SHX-V03	1	Vertical Stab AFT Spar	SHX-V02
Assembly Number	QTY Required	Part Title	Next Assembly
Sonex Highwing Vertical Stab AFT Spar Assembly			
Drawing Scale	Drawing/Assembly Number		Revision
1:3 & Noted	SHX-V03		B

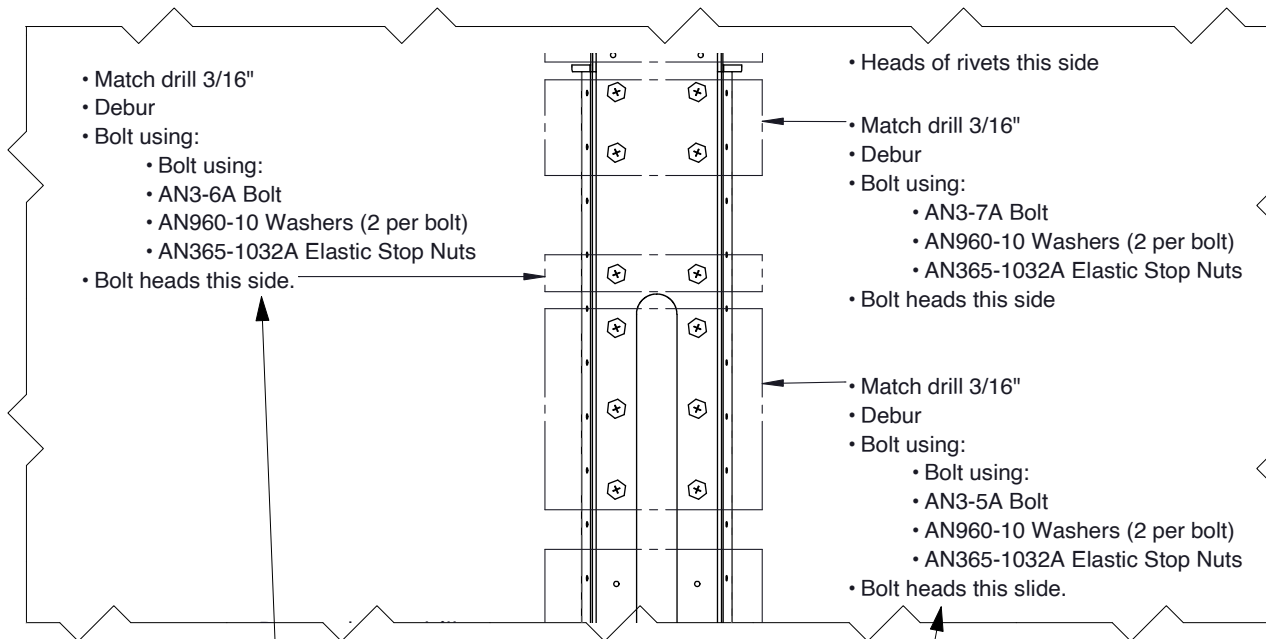
REVISIONS				
ZONE	REV.	DESCRIPTION	DATE	APPROVED
B5	A	Changed rivet head orientation; Rivet head opposite side assigned to two additional rivets. Orientation is required to clear elevator horn at full up elevator.	1.17.26	MCS
A5	B	Corrected bolt callouts; 6 bottom bolts corrected from AN3-7A to AN3-5A; 2 middle bolts corrected from AN3-7A to AN3-6A. BOM is unaffected by this correction.	1.26.26	MCS

Revision Notice:
Bolt lengths corrected
as-shown here.
